Agenda Supplement

January 8, 2025
HDC Meeting

3. 2020 Charlotte Dr (PID 12111102)

HDCRMI-2024-01014

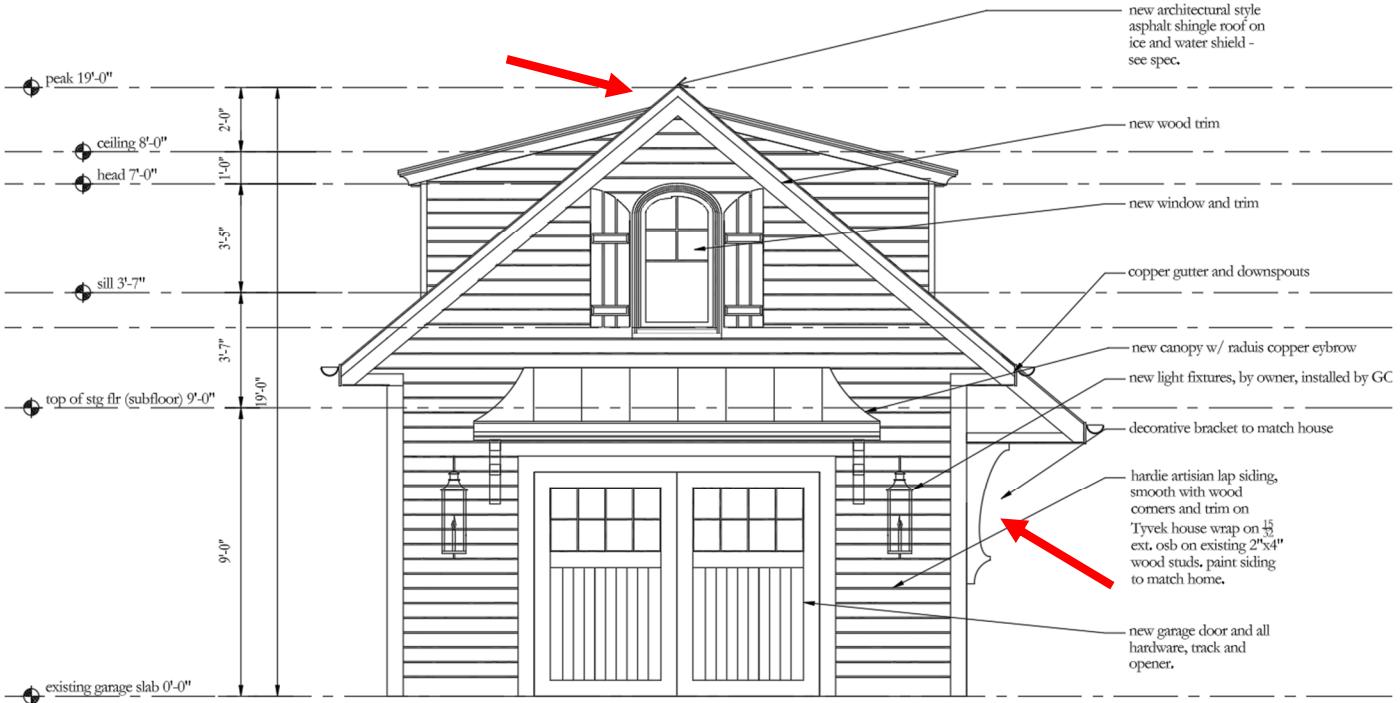
- Dormer roofs should tie in 6" below the main ridge.

- The proposed full height brackets flanking the man-door on the right elevation are too large proportionally for the space.

ELEVATION CHANGED, SEE BELOW

DECORATIVE BRACKETS TO BE REDUCED IN SCALE TO COMPLEMENT EXISTING APPROVED DETAIL ON MAIN HOUSE.

WOOD GARAGE DOOR

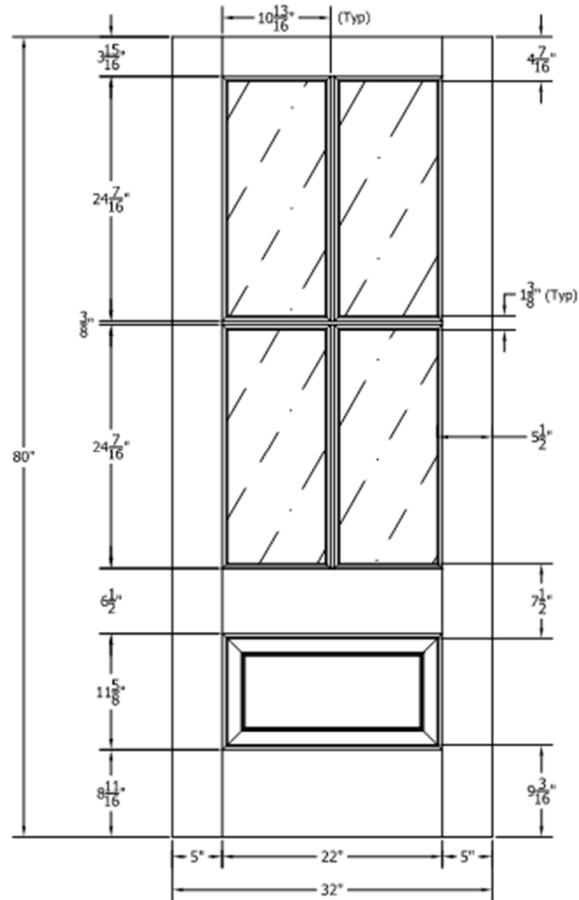
- Material of garage door not provided.

- New garage door and the man door on the right elevation shall be wood.

OWNER TO CHANGE TO PAINTED WOOD (BLACK) SEE ATTACHED

SEE ATTACHED FOR CHANGE
